# PROPOSED SITE DEVELOPMENT

## 46-64 MAPLEWOOD AVENUE

## PERMIT SITE PLANS

PLAN SET ISSUED: 6 FEBRUARY 2018

**C4**

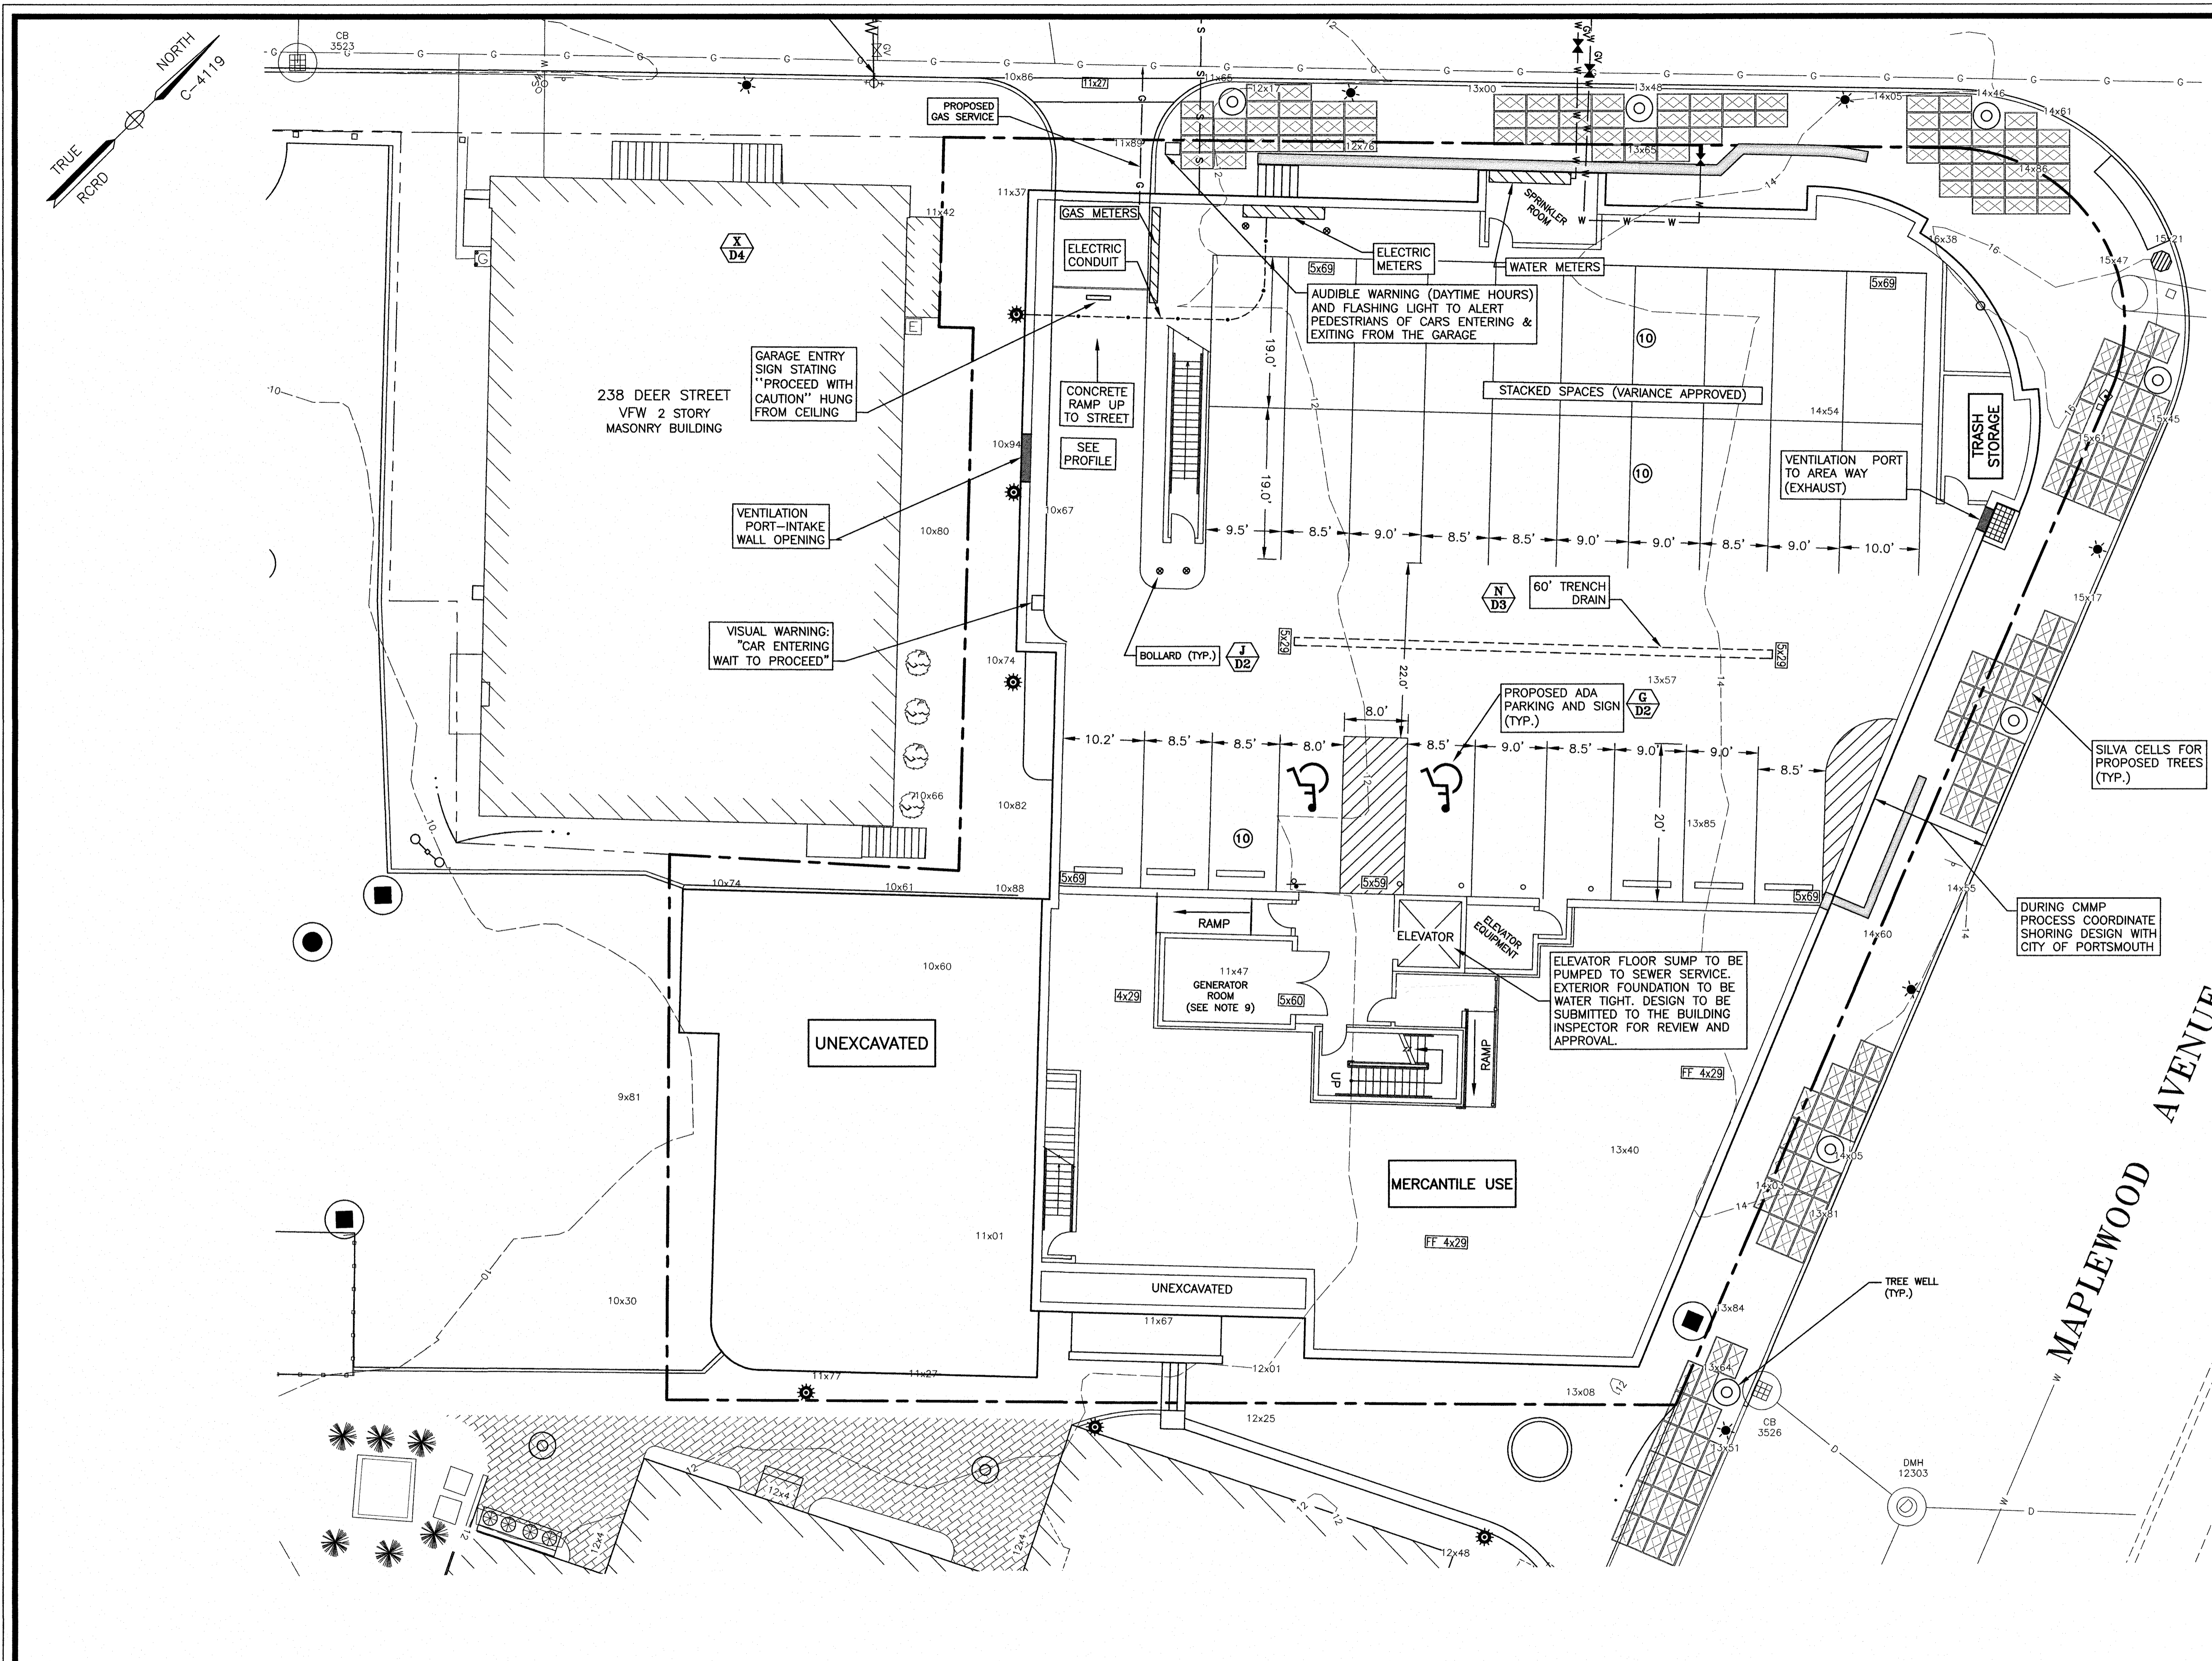
- f. Water meter locations shall be relocated to the sprinkler room, which will be a heated space. **This has been reflected in Sheet C4.**
  - g. Add a note that the elevator sump is to be watertight. **This has been reflected in Sheet C4.**

4. Additional details on solid waste management and proposed plan for future tenants shall be provided prior to Planning Board review. **Please see the Trash Storage Area in the Basement - Sheet C4.**

UTILITY PLAN

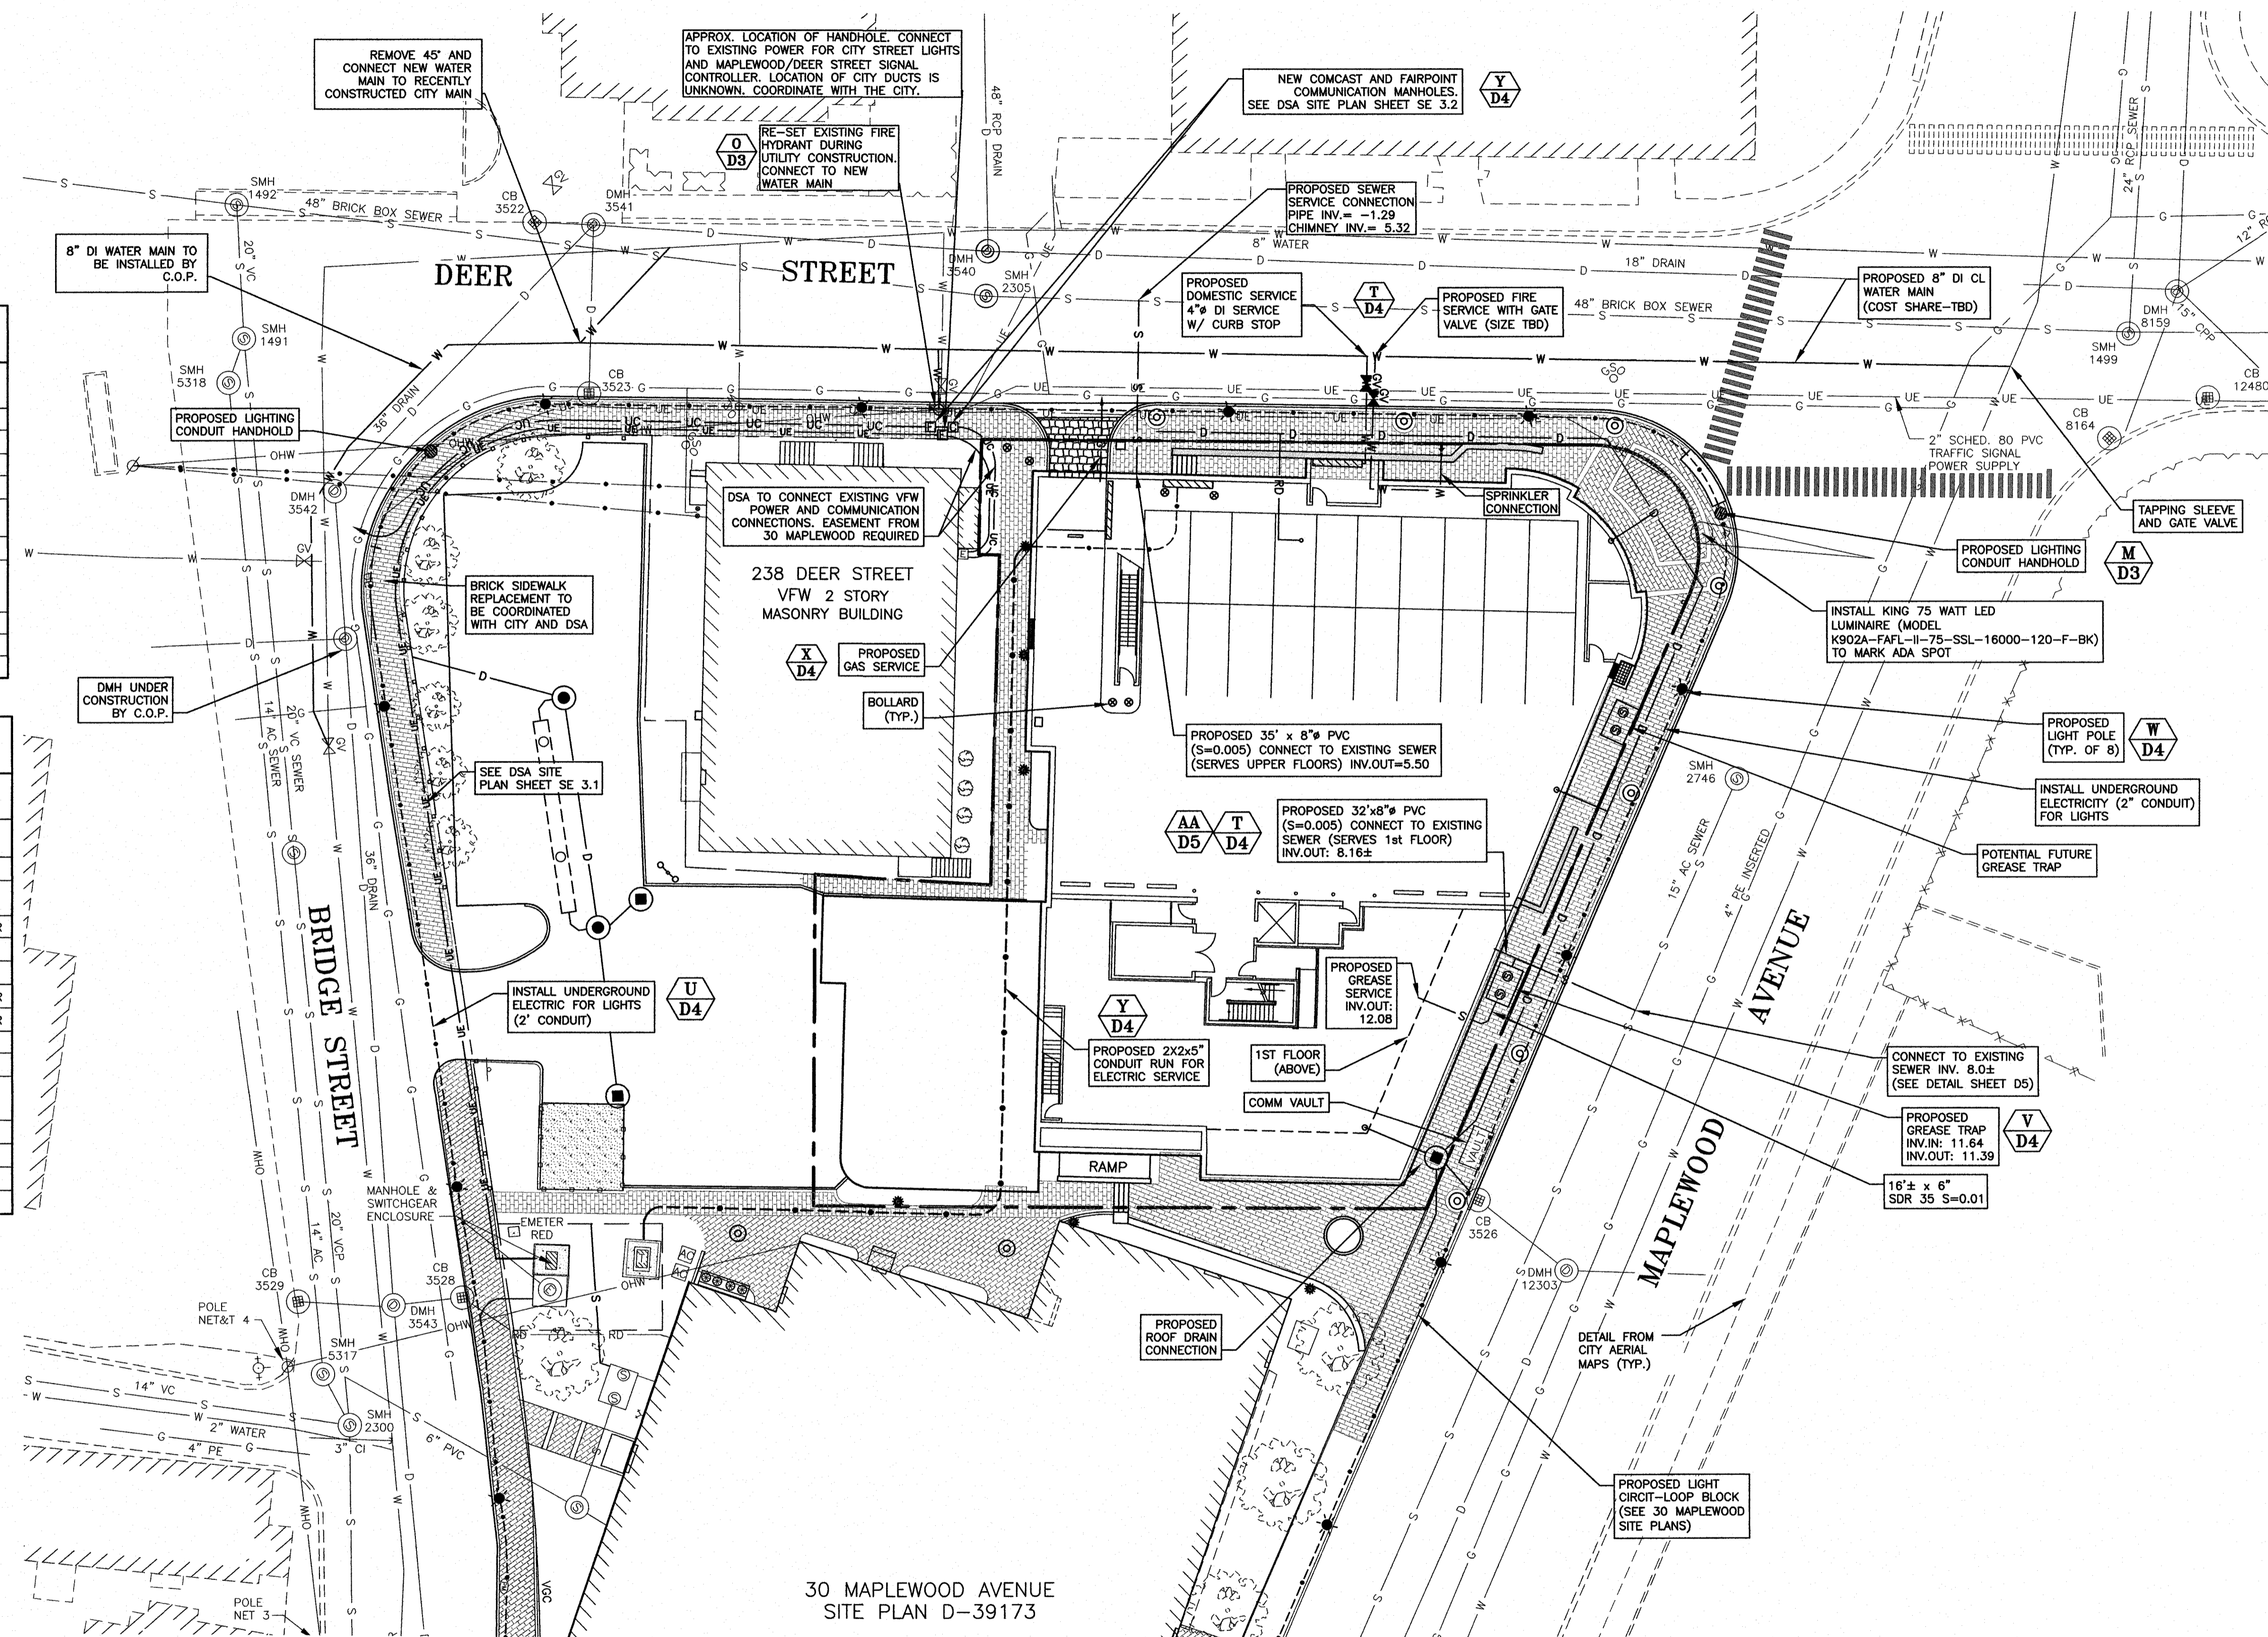
- e. Sewer pipe connections shall be revised to show 8" pipes with the exception of the grease trap which will be adjusted to a slope of 0.01 ft./ft. **This has been reflected in Sheet C5.**

- n. On Sheet C5, show the approximate location of the power for the traffic signal cabinet to 2' off the curb line directly next to the gas line. **This has been reflected on Sheet D5.**

**C6**

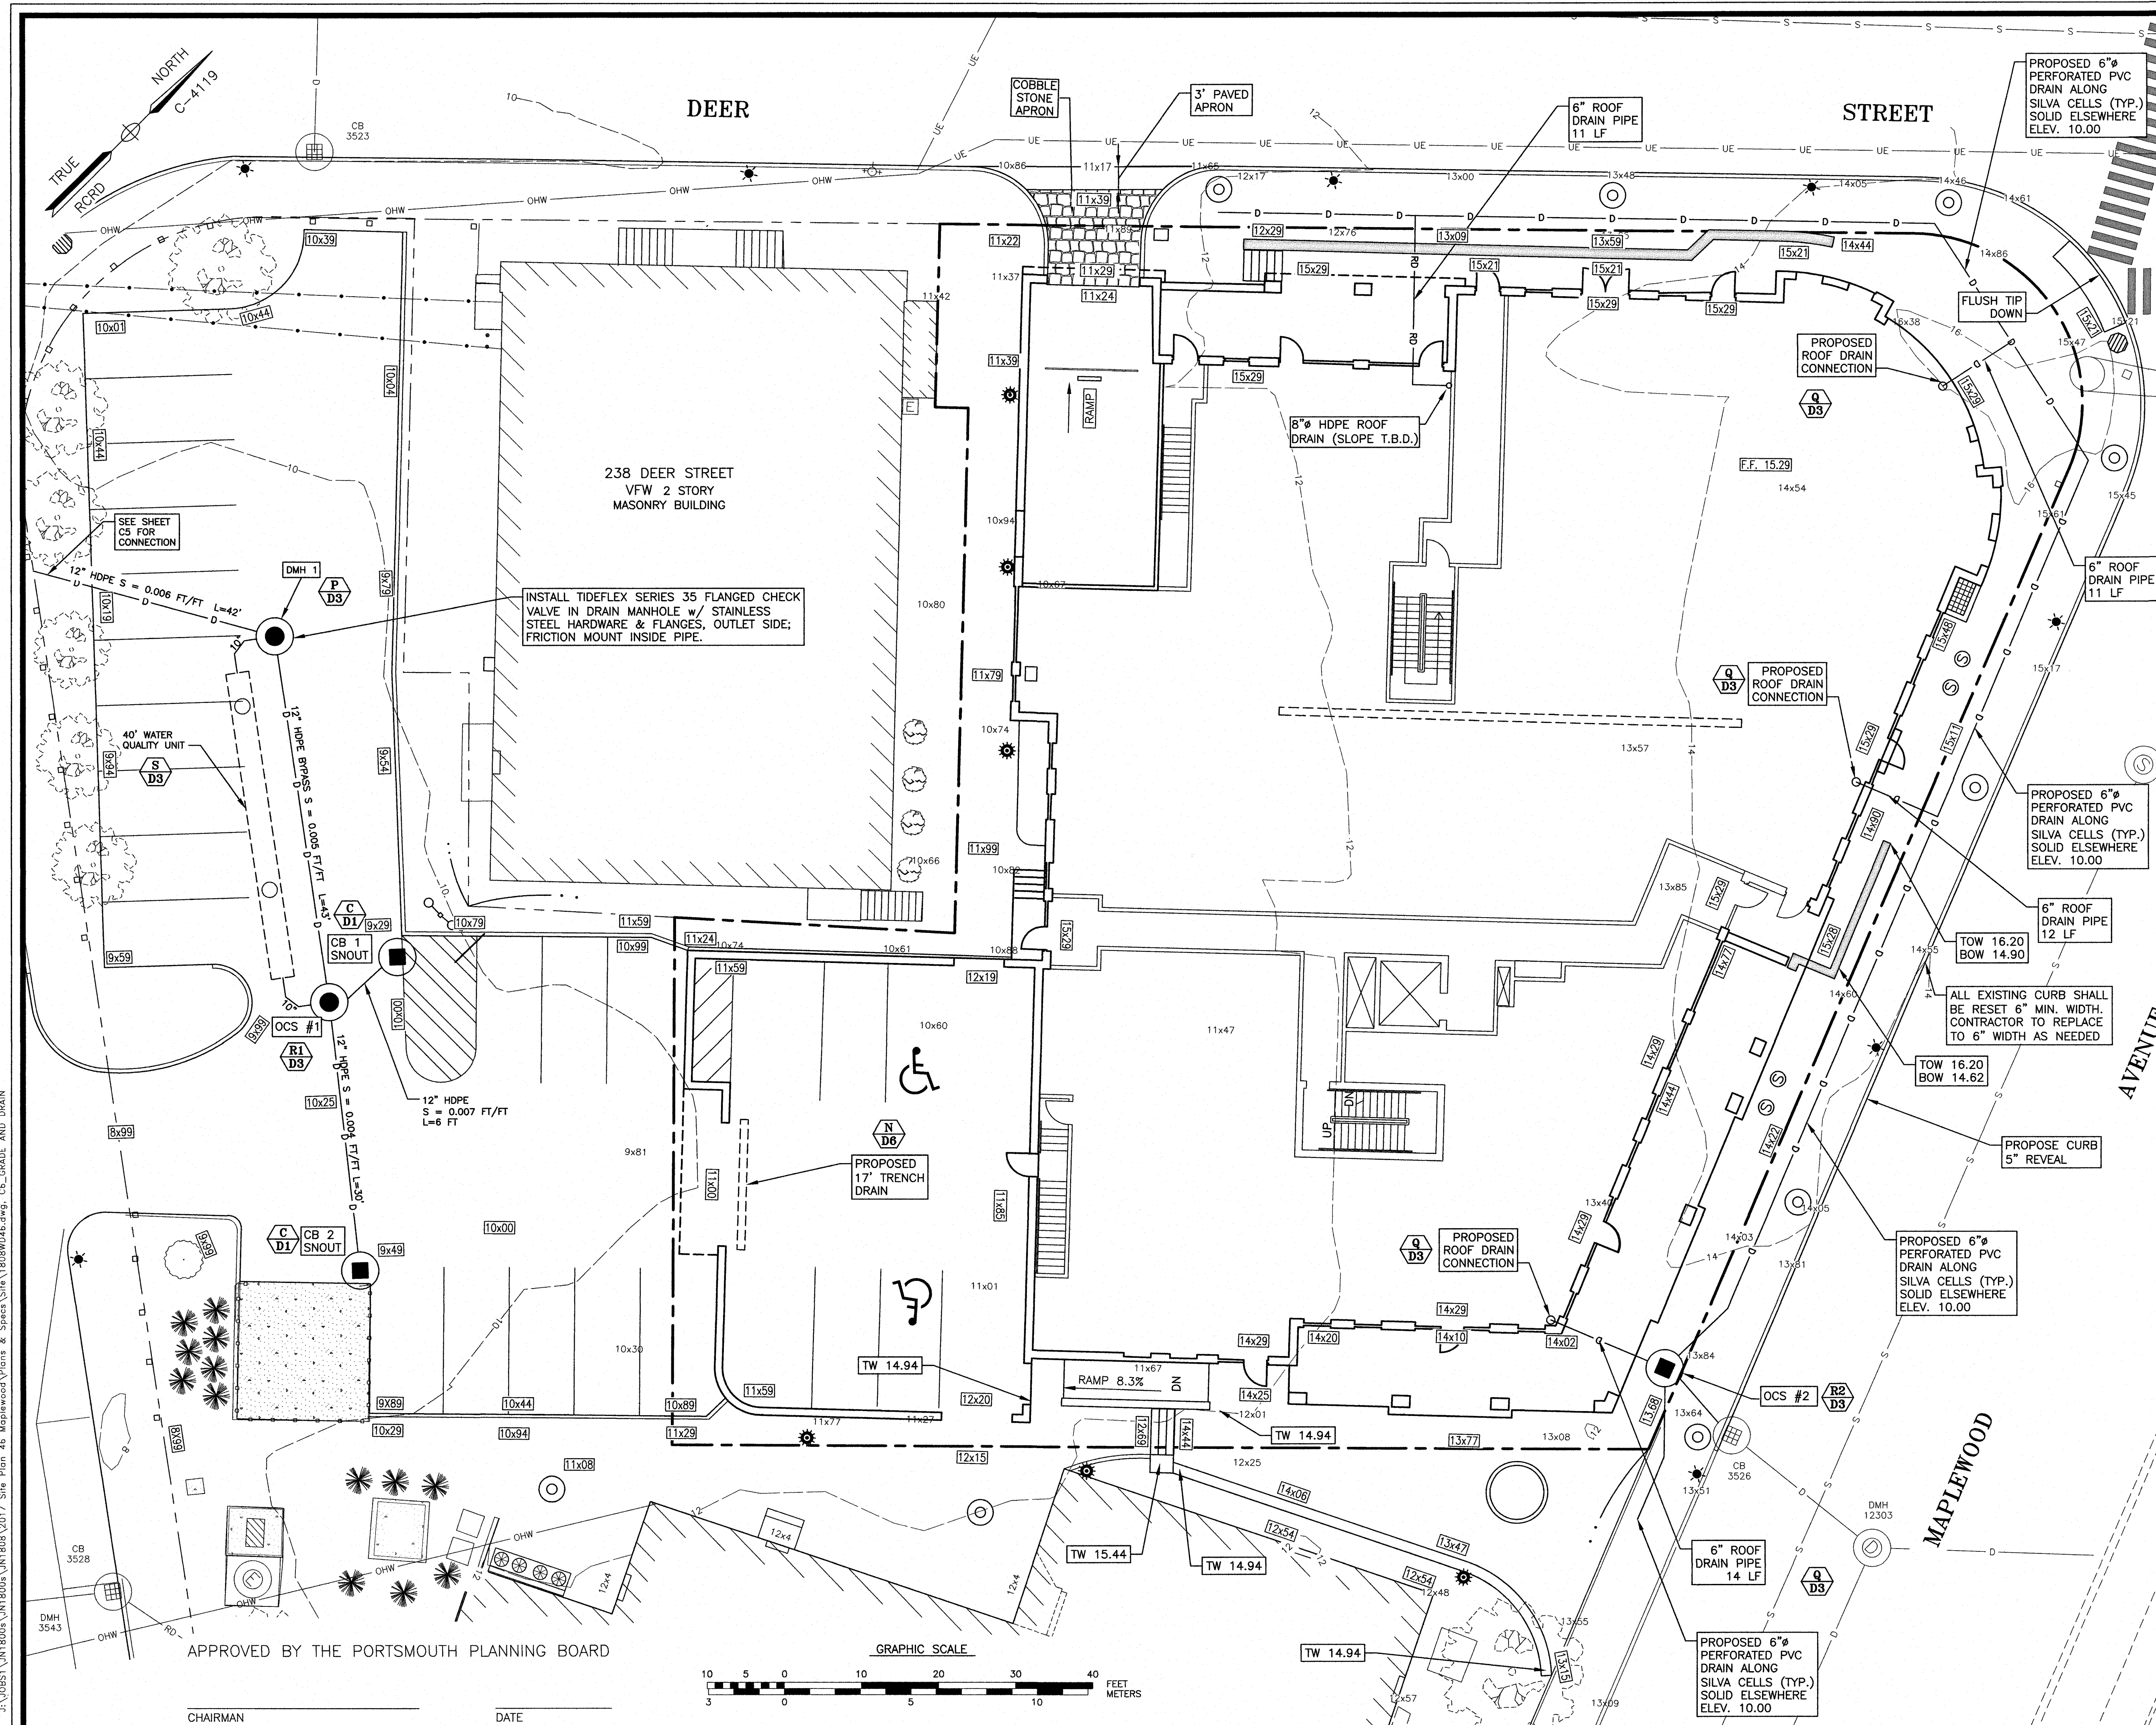
- j. Proposed grade marks shall be removed from the pavement on Deer and Bridge Street. **This has been reflected in Sheet C6.**
  - k. The detail for handholes in the City sidewalk shall be updated as specified. **This has been reflected on Sheet D3 as Detail M.**
